# UNITED STATES PATENT AND TRADEMARK OFFICE

10/529,295

## Office Action Summary

## **DETAILED ACTION**

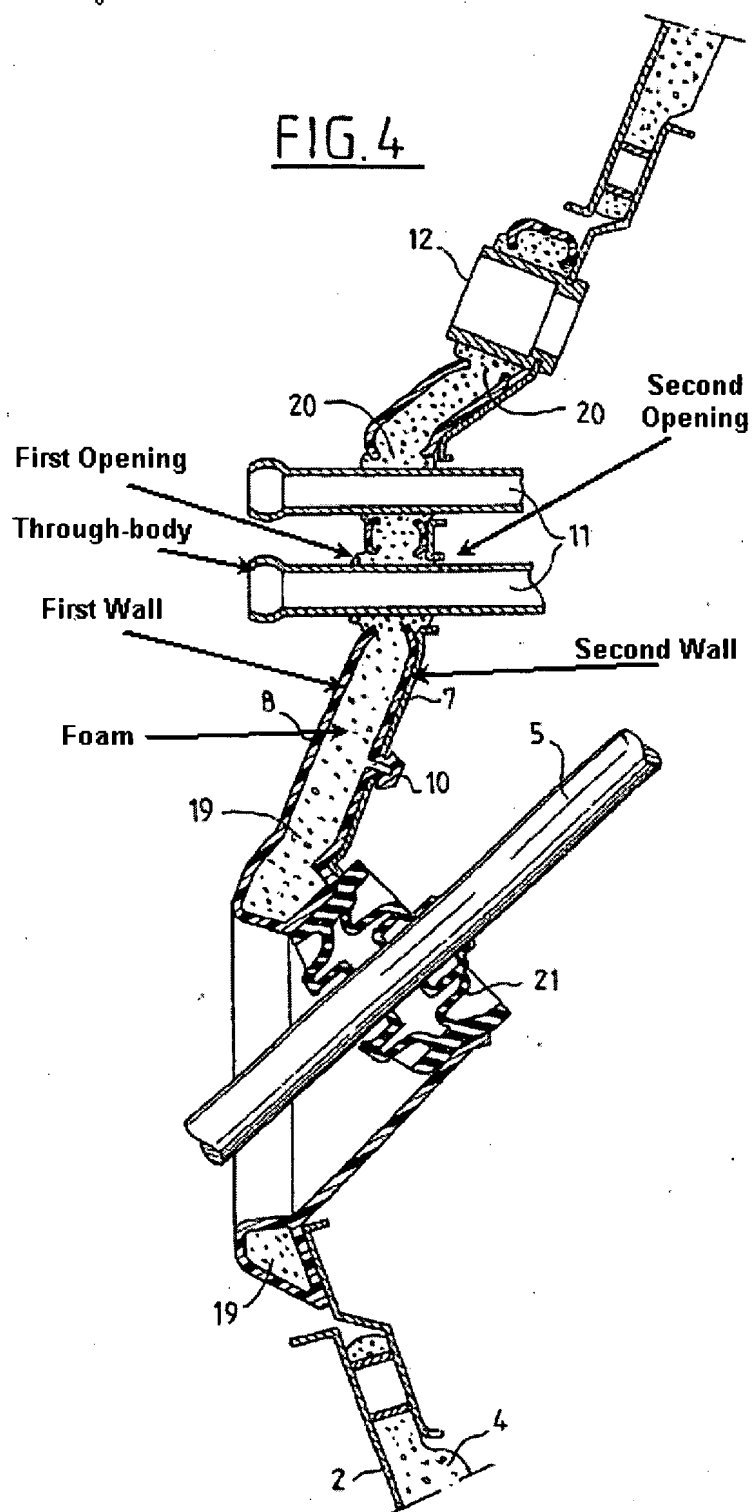
Re claim 13, Dossin discloses an end wall for a motor vehicle, comprising a first wall having an allocated first opening arranged therein, a second wall distanced from the first wall and having an allocated second opening therein, a through-body extending through the first and second openings and defining peripheral gaps between the through body and the respective first and second openings, foam arranged between the first and second walls, which foam bears on at least some regions of the through-body and is disposed in the peripheral gaps, and which foam comprises a foam opening for accommodating the through-body that has a smaller diameter than the through-body in at least some regions when the through-body is not present.

Re claim 16, the foam opening includes a profile in a region of contact with the through-body (see the figure above).

Re claim 17, the foam in the region of at least one of the first and second openings terminates essentially flush with the first or second wall allocated therewith on a side distant to the opposite wall (the foam is essentially flush with the second wall).

Re claim 18, the foam in the region of the first opening projects beyond the first wall to a side distant to the opposite second wall (see the figure above).

Re claim 22, the first wall in the region of the allocated first opening is curved to the side which is distant to the respective opposite second wall (see the figure above).

Re claim 23, at least one of the first and second walls in the region(s) of the respective associated first and second openings comprises a sealing lip (the edge of the openings are sealing lips).

The first and second walls are plastic (see the cross-hatching of figure 4).
